For: DIVERTER VALVE

Serial No.: 10/595,281 Examiner: John C. Fox

REQUEST FOR RECONSIDERATION OF PATENT TERM ADJUSTMENT UNDER 35 U.S.C. § 154 AND 37 C.F.R. § 1.705(b)

Fig. 10

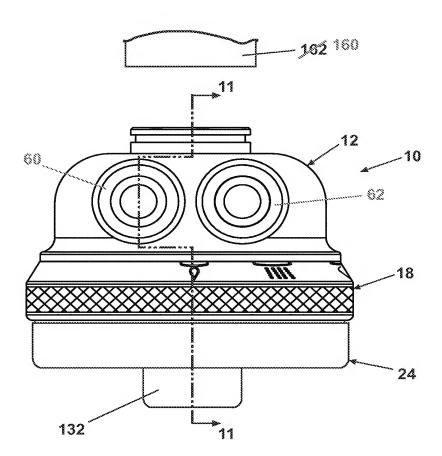
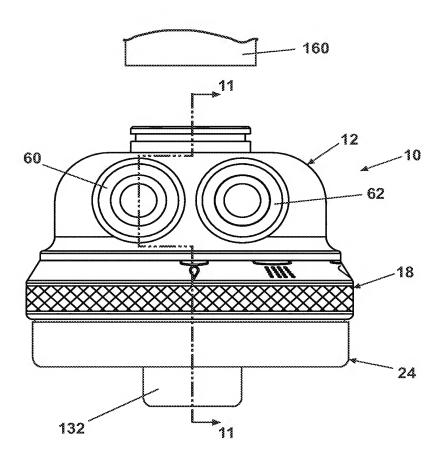
On page 6, line 28, it appears that it should read "mount 20 need not". On page 9, line 1 "an adapter 160" is mentioned but Figures 10,11, 18, 21 show an adapter 162. This adapter 162 also conflicts with seal 162 of Figure 19. On page 11, first full paragraph, both "sealing rings 162, 164, and 166" and "grooves 162, 164, and 166" are mentioned. Notch 174 is not labeled in Figure 19. In Figure 4, "86" labels both 86 and 84.

Fig. 13

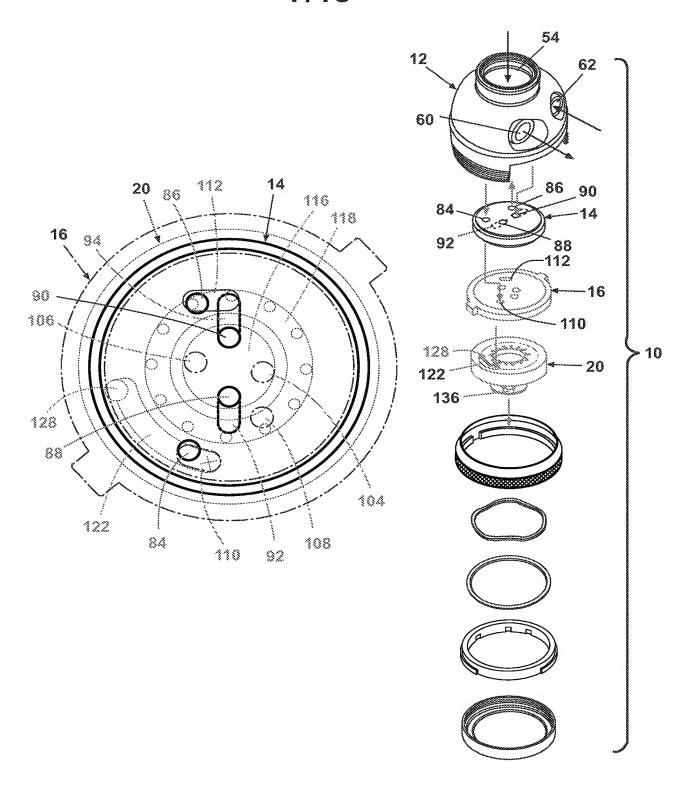
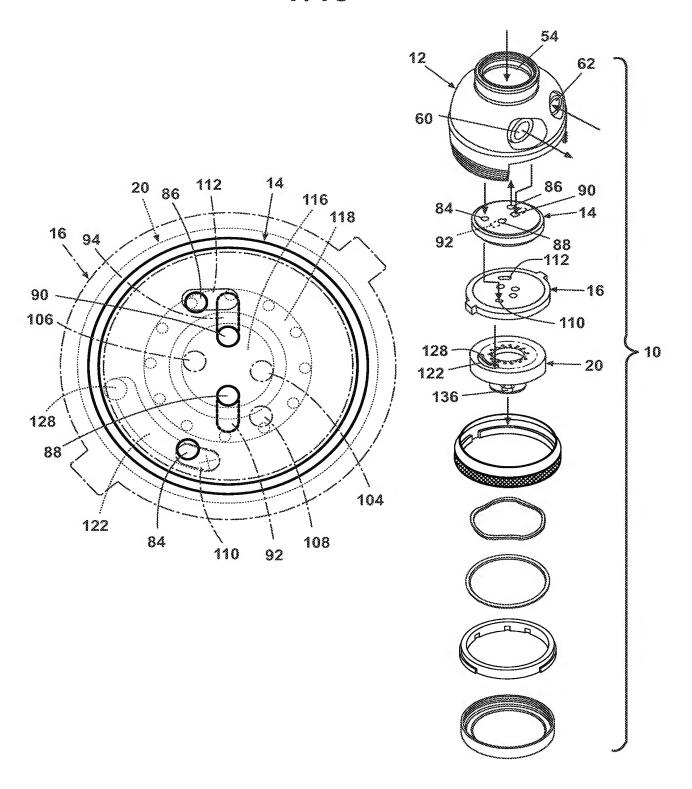
While there is no specific requirement as to how much of the drawings need be labeled, additional labeling would help to understand the invention. Figures 13, 14, 16 have been mentioned. "108" in Figure 5 and "112" in Figure 6 would be helpful. In Figure 11, elements 60, 88, 90, 92, 94, 104, 106, 116, 118, 120, 122, and 128, all of which are important to an understanding of the invention, are visible but unlabeled.
